ADDENDUM #2

BUTANO FARMS SAN FRANCISCO GARTER SNAKE HABITAT ENHANCEMENT PROJECT

This document is in reference to the Request for Bids (RFB) for the Butano Farms San Francisco Garter Snake Habitat Enhancement Project, dated May 19, 2021.

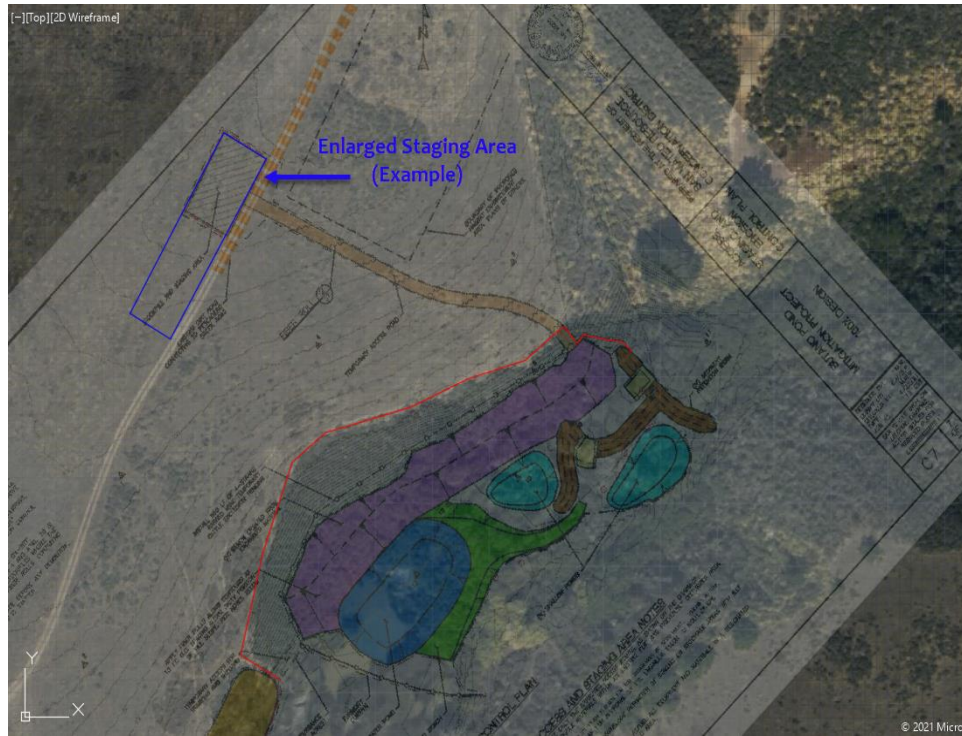
1. CAD drawings of the aquatic activities are available here:  
<https://waterwayscloud.egnyte.com/fl/U9M1OF5Tj8>
2. Questions and Answers. Included below is the Q & A that the RCD received between 6/5/2021 and 6/10/2021:
  - a. Q) Is it acceptable to relocate the livestock exclusion fence so it is outside the vegetation area? (Refer to image below)

A) Yes, this is acceptable. The fence should not extend too far into the grassland (above image is good). The suggested location in the image above would increase the length of fence from 560 linear feet to approximately 690 linear feet.

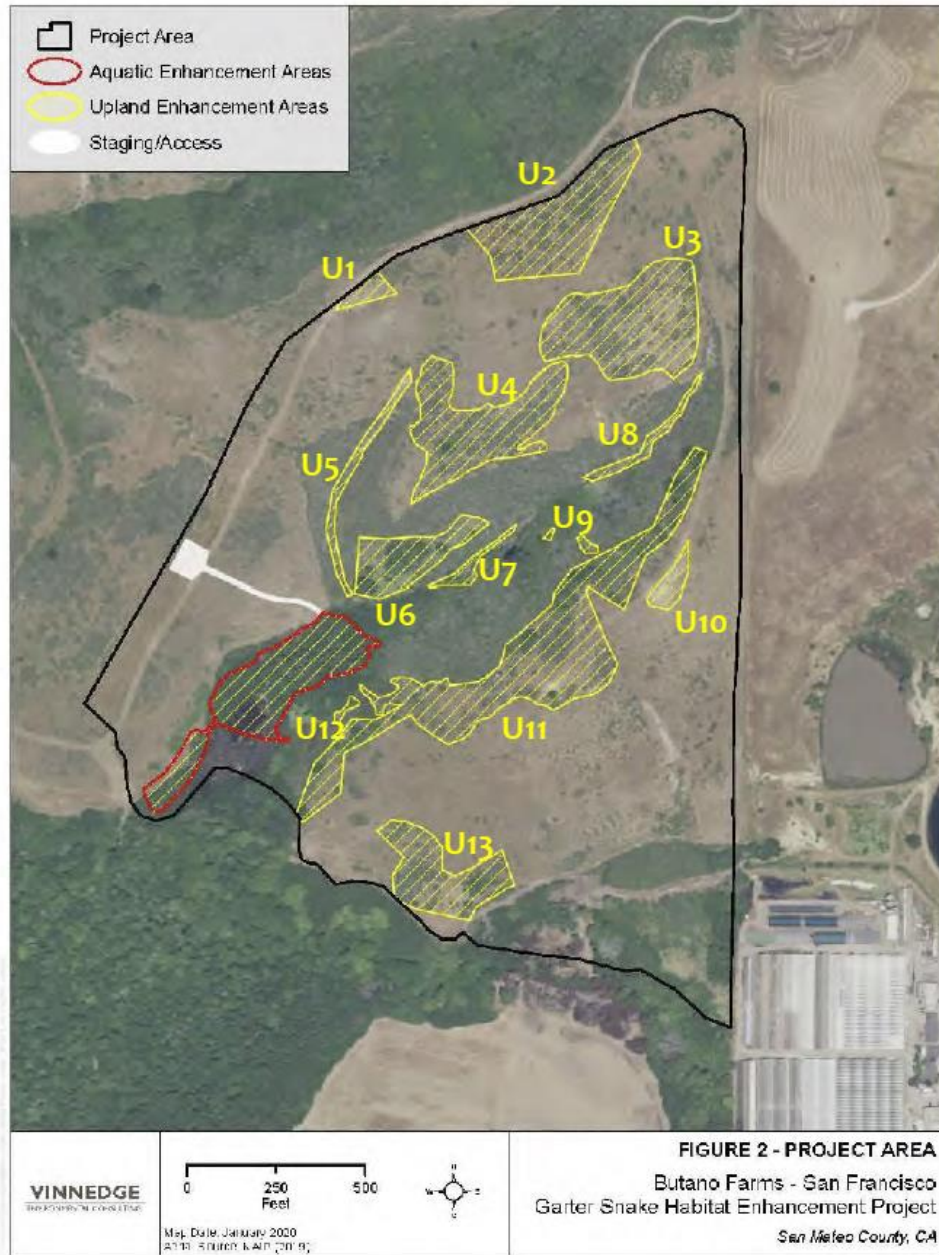
- d. Q) What vehicular access (e.g. 4-wheel drive vehicles) is allowed on the upland enhancement areas as delineated in Figure 2 of the RFB? (See Figure 2 below)

A) Vehicular access to most of these yellow areas above is feasible. Access is to be coordinated with RCD, who will provide monitoring support and approve proposed access route prior to use. Access to U5, U6, U7, U9, U12 is limited and a vehicle will likely not be able to drive directly to these areas. Note that most of those areas are invasive control; U13 is a shrub control area. See the map below (Figure 4 in the RFB).
